CITY PLAN COMMISSION STAFF REPORT

Project Name Summit View Farms

6.1: CD-CPC-2022-00177

6.2: CD-CPC-2022-00178

TYPICAL 28' RESIDENTIAL LOCAL STREET SECTION NOT TO SCALE

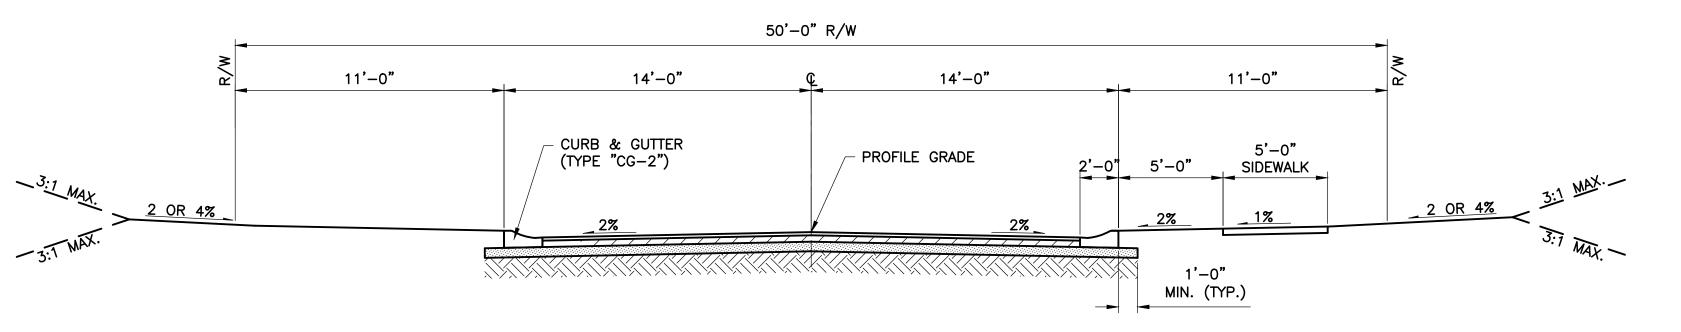
The applicant is requesting a waiver to this requirement to only install sidewalks on one side of the local public streets. Staff is not supportive of this request as it does not meet the public work's standard and will leave the burden of installing the remaining sidewalks on the city down the road. The applicant also has not provided staff with any rationale as required by Section 88-405-25-C-1 below:

The proposed development is asking for a waiver to only provide sidewalks on one side of the local public streets which does not meet the public works standards. Staff is not supportive of this request. See analysis. OA

- 5. a. Sidewalks on both sides of all local public streets within the development.
 - b. A preliminary landscape buffer plan sheet depicting the treatment of the 30 foot POS along Horridge Road as it relates to the existing water main transmission line and for Lots 294-299 and Lot 286. This should include a cross section to ensure that the rear yards are adequately buffered from the public rights of way.
